STAFF REPORT

SUBJECT: H-2022-0081
Guthries – CUP

LOCATION: 1840 W. Chinden Blvd, near the northwest corner of N. Linder Road and W. Chinden Blvd. in the SE 1/4 of the SE 1/4 of Section 23, Township 4N, Range 1W.

Conditional Use Permit (CUP) for a drive-through establishment within 300 feet of another drive-through facility, residential district, and existing residence on 0.969 acres of land in the C-C zoning district.

A. Proposed Site Plan (dated: 10/10/2022)

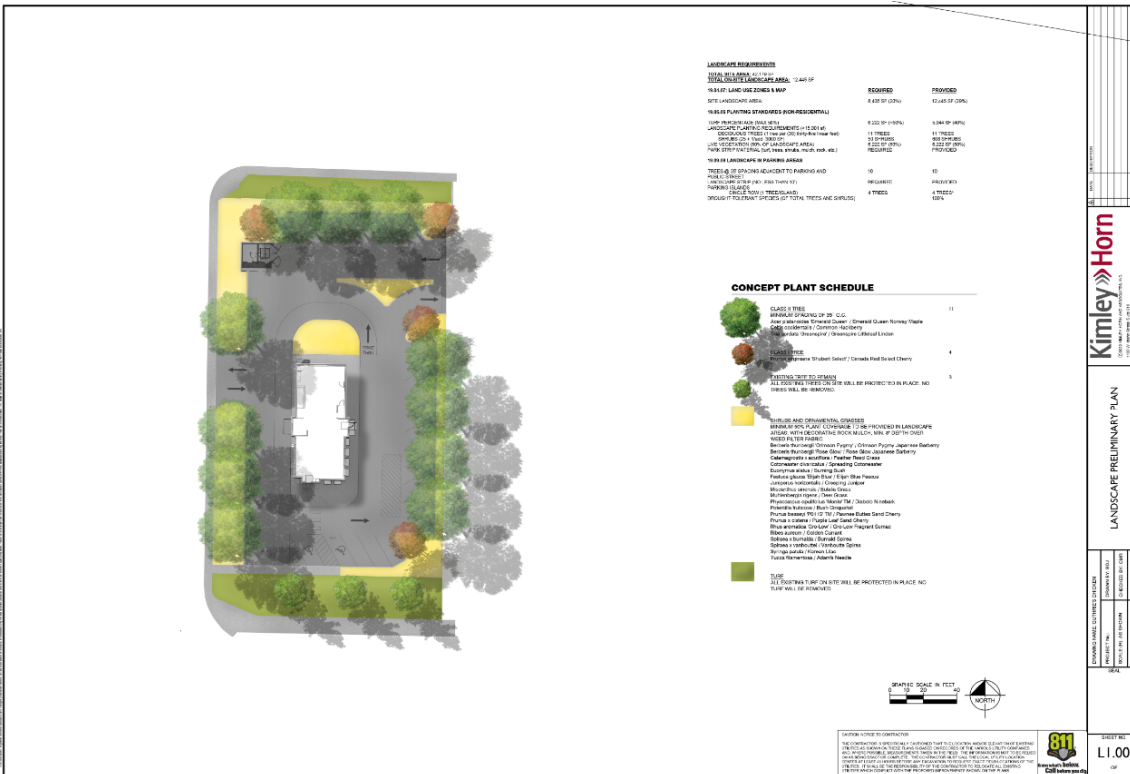
Drive-Through Establishment: The proposed drive-through establishment is subject to the specific use standards listed in UDC [11-4-3-11](#), Drive-Through Establishment. All establishments providing drive-through service are required to identify the stacking lane, menu and speaker location (if applicable), and window location on the site plan. *A menu board, speaker, and window location are depicted on the site plan at the proposed ordering point.* The site plan is also required to demonstrate safe pedestrian and vehicular access and circulation on the site and between adjacent properties. ***Safe pedestrian access should be provided from the vehicle stacking areas on the south sides of the drive-through and along the northeast side of the site – one is required from the perimeter sidewalk along Chinden to the main building entrance. Staff recommends additional pedestrian accesses to the building along the southeast drive aisle per UDC 11-3A-19B.4 and a striped pedestrian walkway on the northeast side of the site directing patrons to the building entrance (see proposed***

redlines on the site plan). Staff recommends signage be installed ahead of each crossing warning drivers to watch out for pedestrians (west, northeast, south). Staff finds that the parking stalls to the north should be restricted for employee parking only to maximize pedestrian safety. At a minimum, the plan is required to demonstrate compliance with the following standards:

The concept plan shows the stacking lane is a separate lane from the drive aisles and parking which provides access to the rest of the development. The proposed site layout places a drive-through that starts at the northeast corner of the building and goes all the way around the building with the exits shown at the northeast corner and west side of the building and also shows the pick-up window on the west side of the proposed restaurant. If there was additional or excessive overflow from the drive-through lane which does sometimes occur from drive-through establishments at peak times, it may stack into the parking lot to the east, north, and then west, not into W. Chinden Boulevard.

The stacking lane is a separate lane from the circulation lanes needed for access and parking, however there is a potential for vehicles to stack in the southern drive aisle.

The stacking lane exceeds 100' in length and an escape lane is required. An escape lane is proposed prior to approaching the ordering window on the west and east sides of the building.

Due to the multiple entrances/exits provided on this site for parking and drive-through access, Staff recommends that the Applicant depict striping and visible signage noting the required traffic flow for the site.

A minimum one (1) bicycle parking space is required to be provided for every 25 vehicle spaces or portion thereof per UDC [11-3C-6G](#); bicycle parking facilities are required to comply with the location and design standards listed in UDC [11-3C-5C](#). ***Bicycle parking is not shown on the plans submitted with this application.***

Pedestrian Walkways: A pedestrian walkway is proposed from the sidewalk along the private road to the main building entrance as required by UDC 11-3A-19.B.4. The proposed pedestrian connection is required to be a minimum of five (5) feet in width. **Where pedestrian walkways cross vehicular driving surfaces, they're required to be distinguished from the vehicular driving surface through the use of pavers, colored or scored concrete, or bricks as set forth in UDC 11-3A-19B.4. The site/landscape plan submitted with the Certificate of Zoning Compliance application should reflect compliance with this standard – the proposed striping of the crosswalk is not allowed and should be revised to comply with this standard.**

2. The site plan and landscape plan submitted with the Certificate of Zoning Compliance application shall be revised as follows:
 - a. The stacking lane, menu and speaker location(s), and window location shall be depicted in accord with UDC [11-4-3-11B](#).

- c. The pedestrian walkway from the perimeter sidewalk along Chinden to the main building entrance shall be distinguished from the vehicular driving surface through the use of pavers, colored or scored concrete, or bricks as set forth in UDC 11-3A-19B.4b.; the two additional required pedestrian walkways to the main building entrance(s) may be striped.

- d. Depict signage ahead of each pedestrian crossing(s) in the drive-through lane (south and northeast) notifying drivers to watch out for pedestrians.

- e. Depict signage along the parking stalls to the north restricting the stalls for employee parking only to maximize pedestrian safety.
 - f. Additional signage and parking lot striping is required throughout the site to efficiently and adequately direct patrons to the menu boards and throughout the site with minimal conflict.

- i. Depict one bicycle rack as close to the building entrance as possible without obstructing pedestrian walkways, public sidewalks, or building entrance(s) in accord with UDC [11-5-3C-5](#) and UDC [11-3C-6G](#).

B. Proposed Landscape Plan (dated: 10/18/2022)

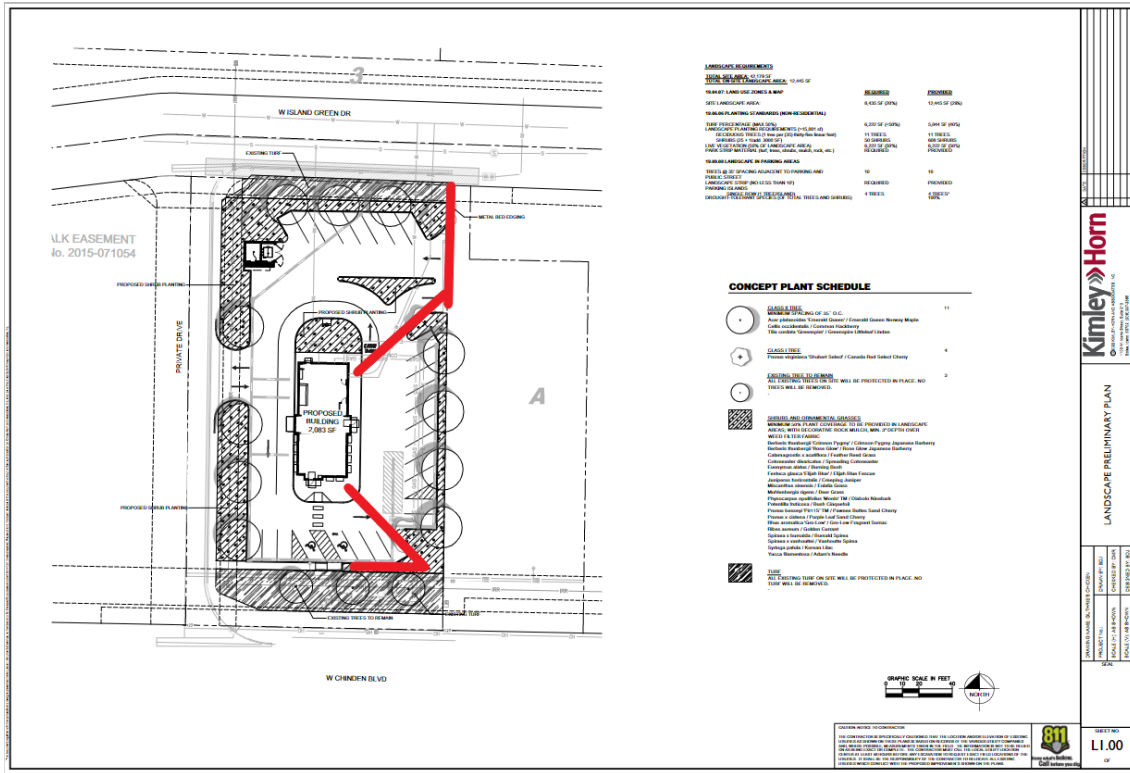
No elevations were submitted that show the proposed trash enclosure; this should be corrected with the future CZC submittal and should match the style of the proposed building. The submitted landscape plans do show adequate screening of the trash enclosure.

- g. Depict landscaping in the perimeter buffer and within the parking area in accord with the standards listed in UDC [11-3B-8C](#).
 - h. Depict signage ahead of each pedestrian crossing(s) in the drive-through lane (south and northeast) notifying drivers to watch out for pedestrians.
